INITIAL FIRE SAFETY INSPECTION REPORT

Silver Composite Textile Mills Ltd. (Extension)

RSC ID: 26398

Date: 07-October-2025

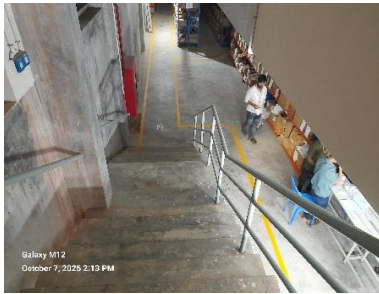
SI No.	Category	Findings	Required Action	Remediation Time Frame
F-1	Means of Egress	The exit stair enclosures are not separated from work areas and other spaces on each floor by fire-rated construction Location(s): Garmentss Building-2, Non-compliance: 1. Unprotected opening at basement floors. 2. Non-functional installed fire doors. 3. Installed fire doors were not effectively latching. 4. Open by external objects.	The exit stair enclosure shall be provided with a minimum of 2-hr. fire resistance rating for buildings 4 or more stories. Provide 1.5 hr. fire rated door and seal all penetrations and openings by 2 hr. fire rated fire rated barrier construction for building with 4 or more stories in accordance with section 6.3.1.2 of RSC Technical Guidelines (Standard)¹ V1.0. Provide a fire-resistive rated assembly between the exterior exit stairs and the building up to 10 ft. beyond the end of the stair to achieve the required separation. The rated assembly shall be approved and/or designed by a qualified fire protection engineer. Ensure that the fire doors are self-closing and positive latching and that they are provided with fire exit (panic) hardware where serving production floors. If fire doors are required to be held open for functional reasons, provide automatic closing devices tied to the fire alarm system. Keep proper datasheet & certifications for installed fire doors & accessories on-site for verification. The clearance under the bottom of a door shall be a maximum of 3/4 in. (19 mm).	Within 3 Months

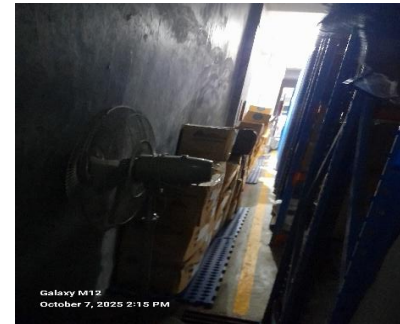
F-2	Means of Egress	The egress path along means of egress has interrupted by storage Location: Basement floor of the Garments Building-2.	Keep egress paths and stairs clear of storage/obstruction in accordance with section 6.3.9 of RSC Technical Guidelines (Standard)¹ V1.0. Means of egress shall be maintained continuously free and clear of all obstructions or impediments to full instant use in the case of fire or other emergency. No furnishings, decorations, or other objects shall obstruct exits and access to exits. Nothing shall obstruct or impede visibility to exits.	Immediately
-----	-----------------	---	--	-------------

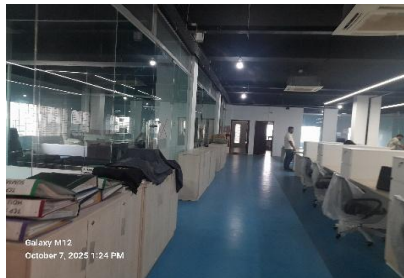
F-3	Means of Egress	Posted Fire evacuation maps are not updated as per site conditions. Location(s): Garments Building-2 & all other structure.	Update the fire evacuation map and shall be posted at the entrance to each exit stair in accordance with RSC Technical Guidelines (Standard)¹ V1.0 Section 13.3.	Within 1 Month
F-4	Means of Egress	Aisles were found missing in several locations of the Garments building-2. Location: 4th & 5th floor of the Garments Building-2.	Provide minimum aisle widths of 36-in. Aisles mark shall be clearly visible.	Within 1 Month

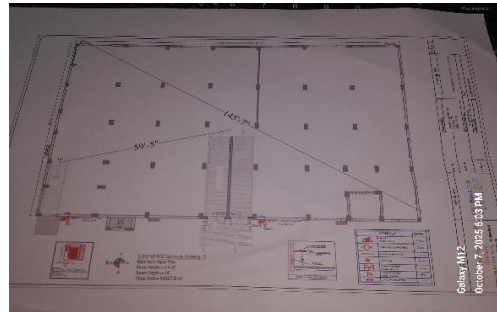
F-15	Means of Egress	The exits are not remotely located from each other such that a single fire event could compromise both exits of the building. Location: Basement floor of the Garments Building-2. Diagonal Distance: 145feet 7inch. Exit Distance: 59 feet 5inch.	Provide additional exit or reconfigure the exit arrangement to ensure that the exit doors or means of egress openings are located a distance apart as per RSC Technical Guideline (Standard) section of 6.6.6.	Within 3 Months
------	-----------------	---	---	-----------------

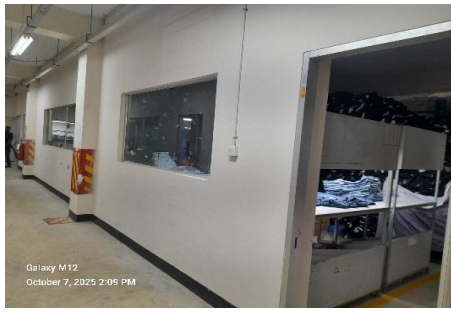
F-20	Means of Egress	Storage areas & basements and similar normally unoccupied spaces discharges directly into the exit stair enclosure. Location(s): Basement floors & First floor to 3rd floor of the Garments Building -2.	Openings from exit enclosure to Storage areas/ basements/ transformer rooms/ generator rooms/ boiler rooms and similar normally unoccupied spaces shall be provided with a vestibule with fire rated construction and openings in accordance with section 6.14.3 of RSC Technical Guidelines (Standard)¹ V1.0. Provide a min 1-hr fire rated door on the exit stair side and a 1.5 hr./1-hr fire rated door on the Store, generator, sub-station room side . Ensure that the fire rating of the vestibule construction matches that of the exit stair enclosure as per RSC Technical Guidelines (Standard)¹ V1.0. section 6.14.3. The minimum width for vestibules shall not be less than 1.1m and length 1.8m.	Within 3 Months
